FINAL PLAT OF  
"MARIE'S MEADOW"  
SEDGWICK COUNTY, KANSAS  
IN THE NORTHWEST QUARTER OF SECTION 4,  
TOWNSHIP 28 SOUTH, RANGE 2 WEST OF THE 6TH P.M.

RE: SUB 2003-20 -- One-Step Final Plat of Le' Marie Addition

RE: SUB 2003-20 -- One-Step Final Plat of Le' Marie Estates Addition

**CASE NUMBER:** SUB 2003-20 -- LE' MARIE ESTATES

FINAL PLAT OF  
**"MARIE'S MEADOW"**  
 SEDGWICK COUNTY, KANSAS  
 IN THE NORTHWEST QUARTER OF SECTION 4,  
 TOWNSHIP 28 SOUTH, RANGE 2 WEST OF THE 6TH P.M.

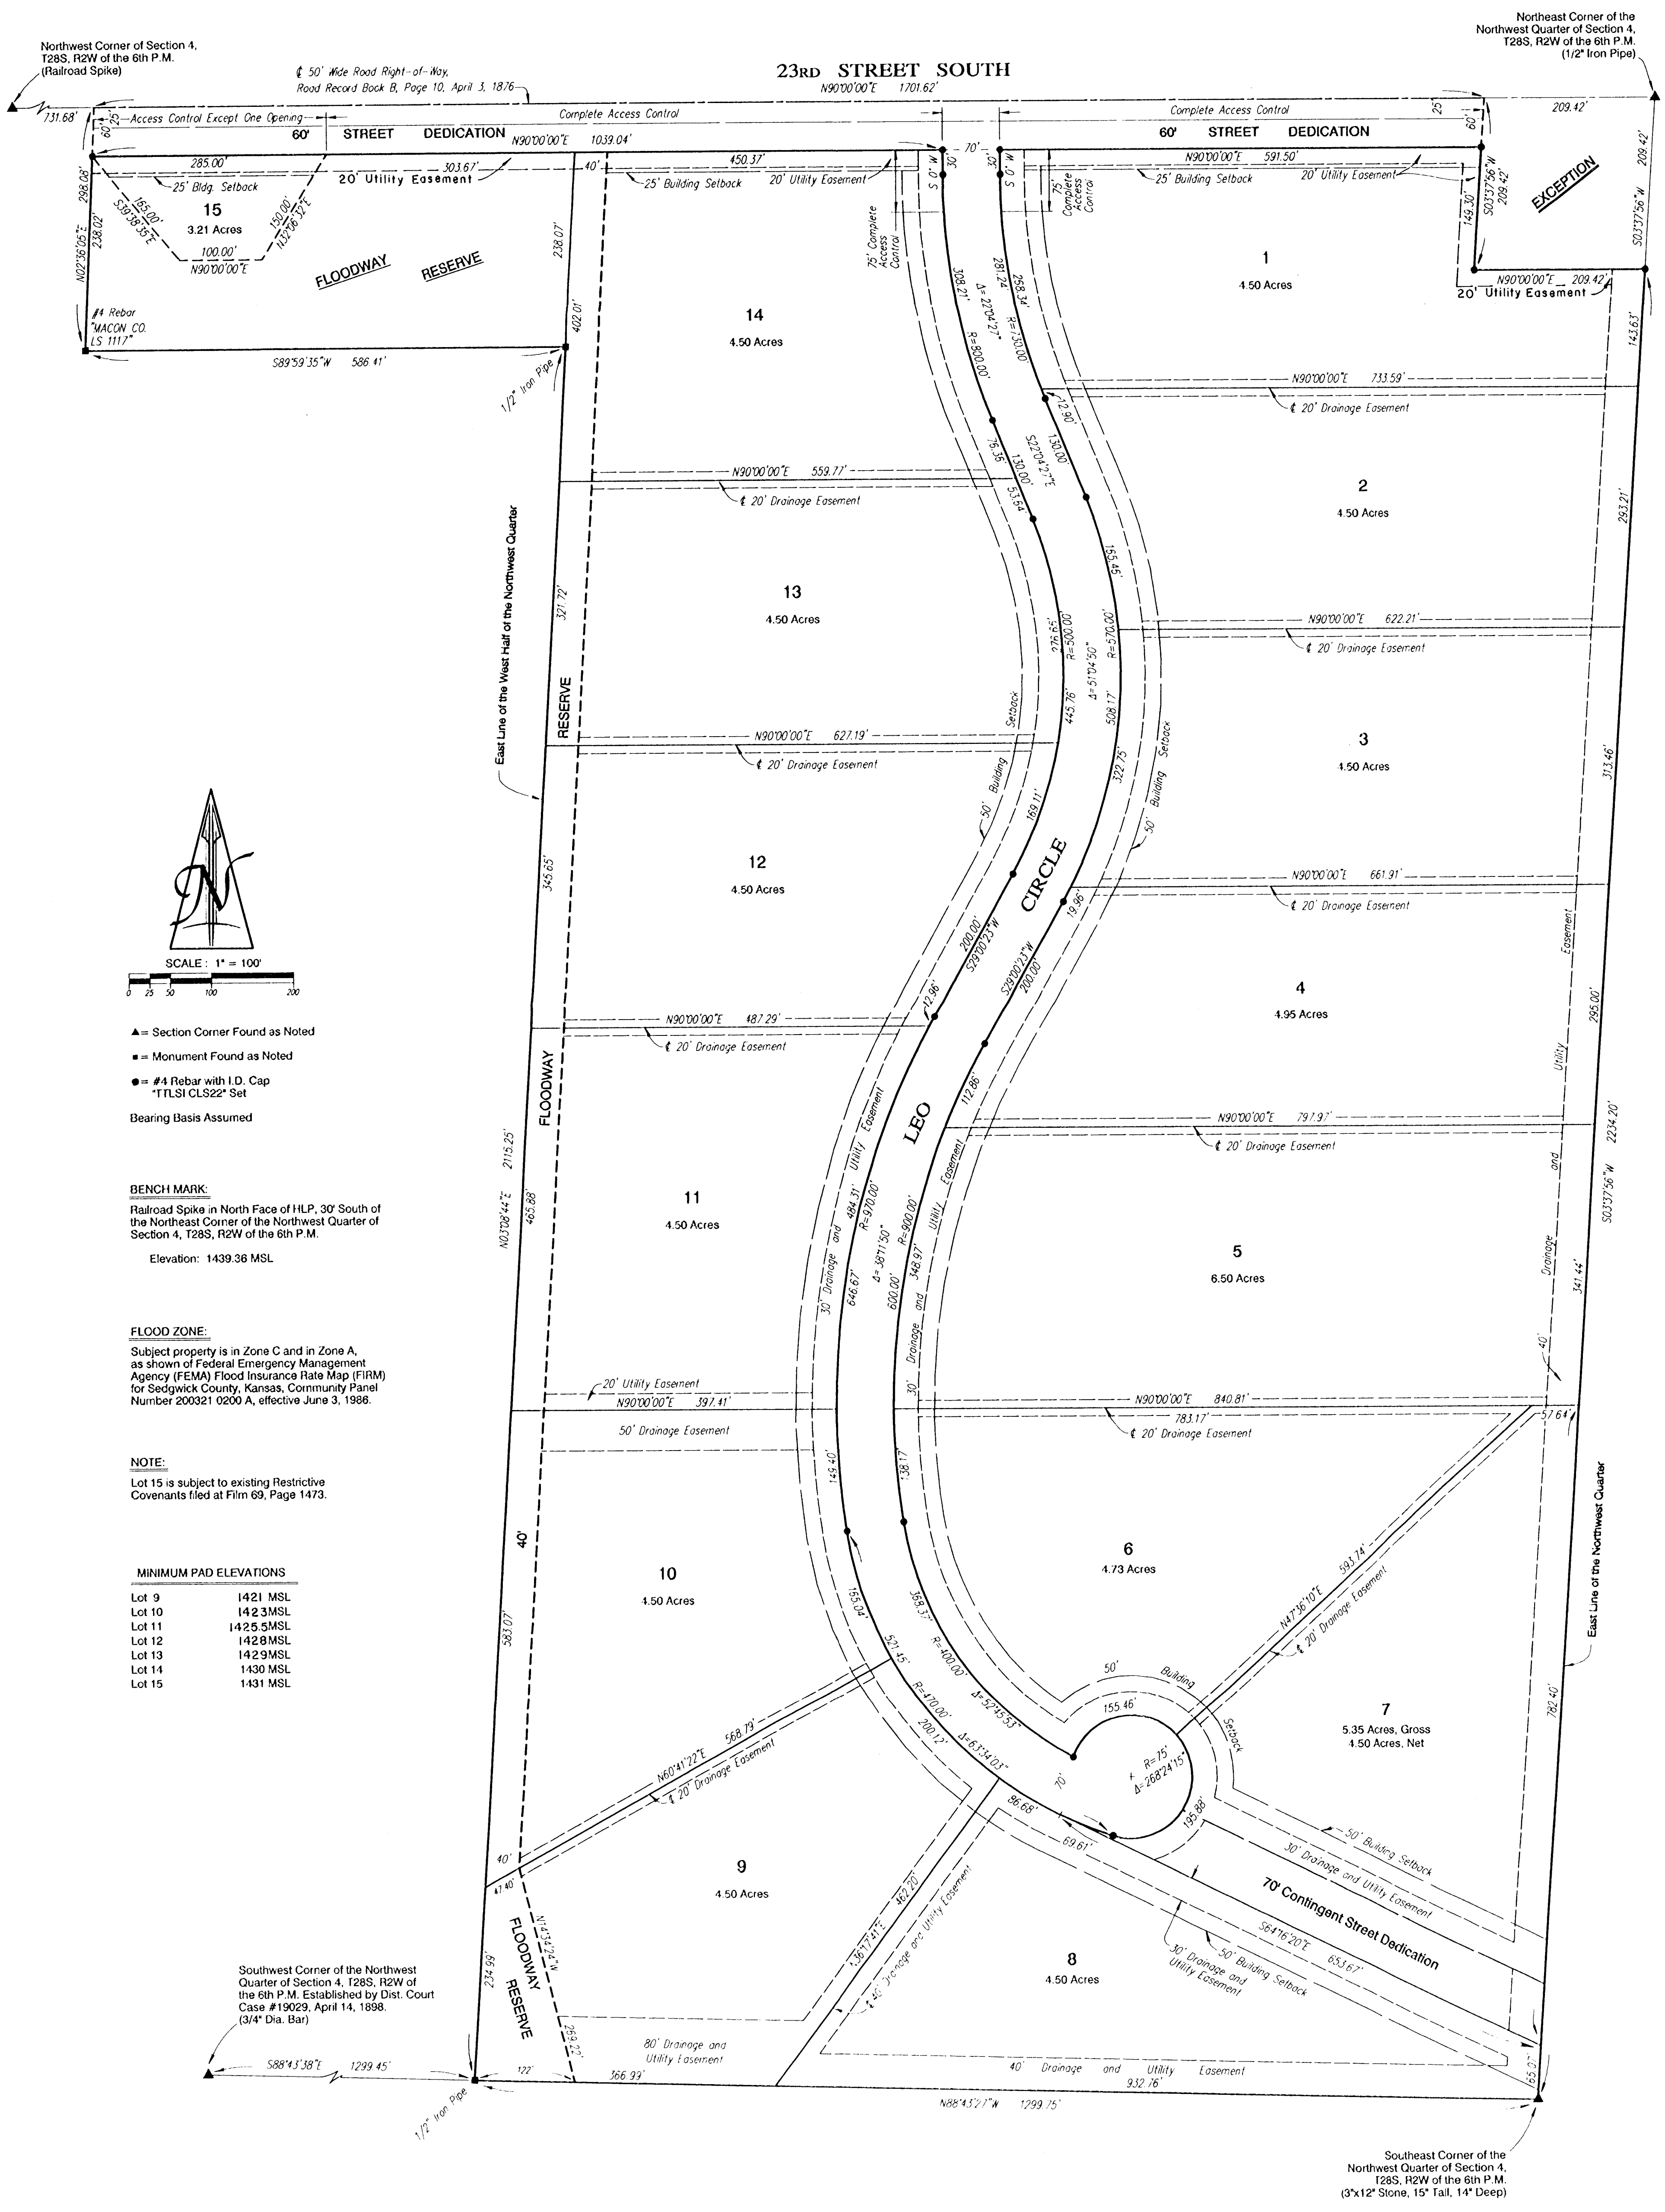
- E. **County Engineering** needs to comment on the status of the applicant's drainage concept. *A drainage plan is needed. The drainage plan needs to address effect of terraces. A flood study is needed. Minimum pads need to be set for lots 9 through 15, based on flood study.*

- F. **County Engineering** needs to comment on the access controls. The plat denotes complete access control to 23<sup>rd</sup> St. for Lots 1 and 14. *Access control except one opening shall be dedicated for Lot 15. Complete access control is needed along the north 75 feet of the west line of lot 1 and the north 75 feet of the east line of Lot 14.*

- I. **County Fire Department/County Engineering** needs to comment on the street length of the proposed cul-de-sac (2,300 feet). Rural cul-de-sacs over 1,200 feet in length must provide a stub street connection or contingent street dedication providing future access to adjoining tracts, or an emergency access easement. **A contingent street dedication is needed between Lots 7 and 8.**

- J. **County Engineering** requests a contingent dedication of street right-of-way between Lots 7 & 8 in order to provide potential street connection to adjoining properties. On the final plat, the contingent dedication of right-of-way needs to be referenced in the plat's text.

- K. The drainage easement between Lots 8 & 9 should be increased to 40 feet.
- L. The applicant is reminded that this site is located within three miles of the City Limits of Wichita and will be heard by City Council. Therefore, the City Council signature block needs to be included on the final plat.

- O. The applicant needs to assign a name for the new street. **Leo Circle will be the street name.**
- P. The floodway reserve within Lot 15 shall be denoted by a dashed line.
